Subject: Workplan for the General Mail Facility, Oakland, California

**RE: SITE CHARACTERIZATION WORK PLAN
U.S. POSTAL SERVICE VEHICLE MAINTENANCE FACILITY
1675 - 7TH STREET
OAKLAND, CALIFORNIA**

SITE CHARACTERIZATION WORKPLAN
UNITED STATES POSTAL SERVICE
VEHICLE MAINTENANCE FACILITY
OAKLAND, CALIFORNIA

FIGURE
2

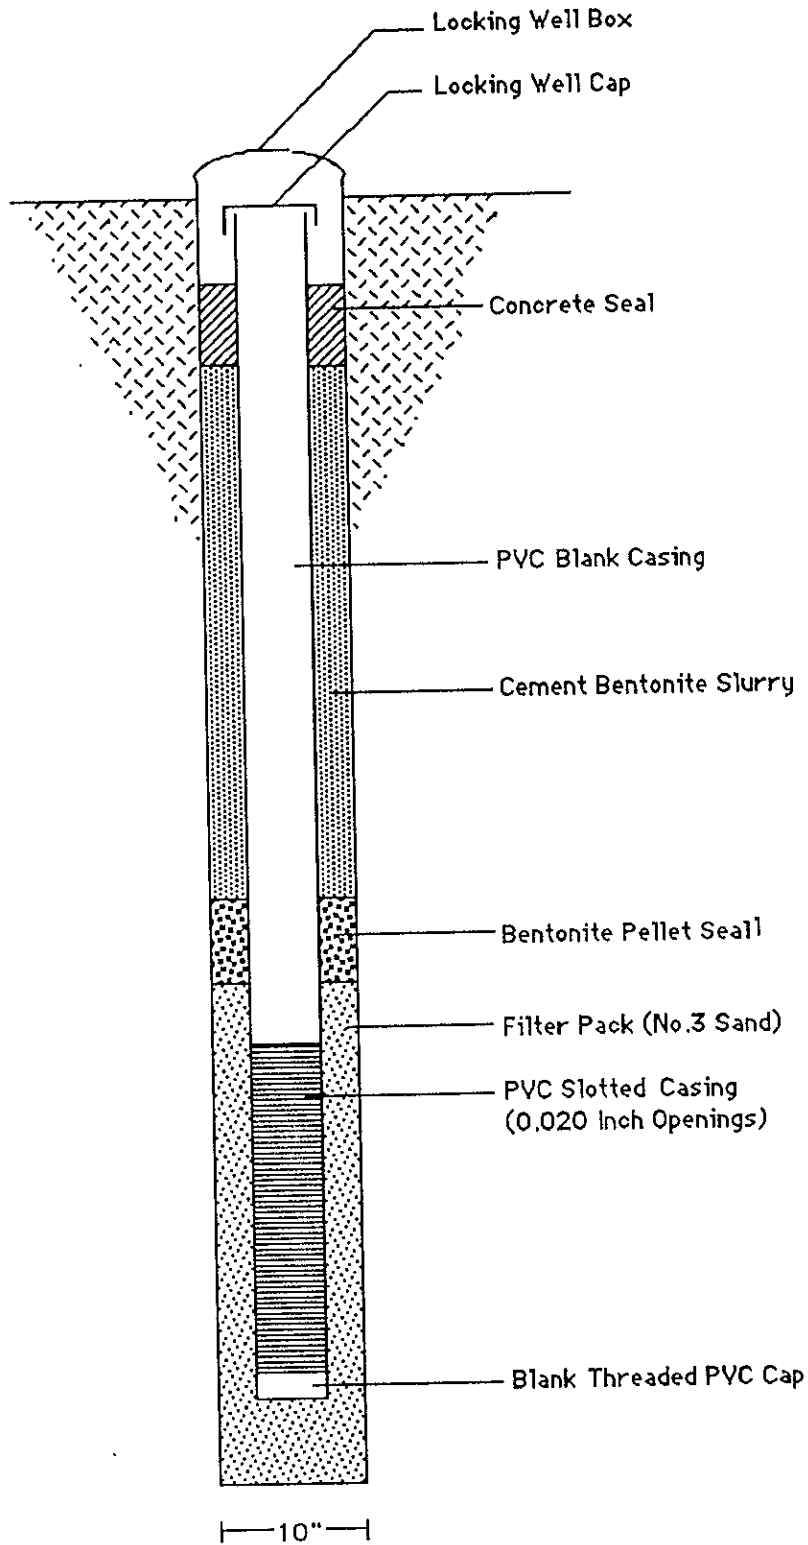
5 MWS
3 SBS

diesel (Tank 5)

? Four borings (MW-1 through MW-4) will be drilled near the two removed 10,000-gallon diesel USTs and completed as groundwater monitoring wells. MW-5 will be drilled near the removed 10,000-gallon gasoline UST near the mail sorting building, and completed as a groundwater monitoring well.
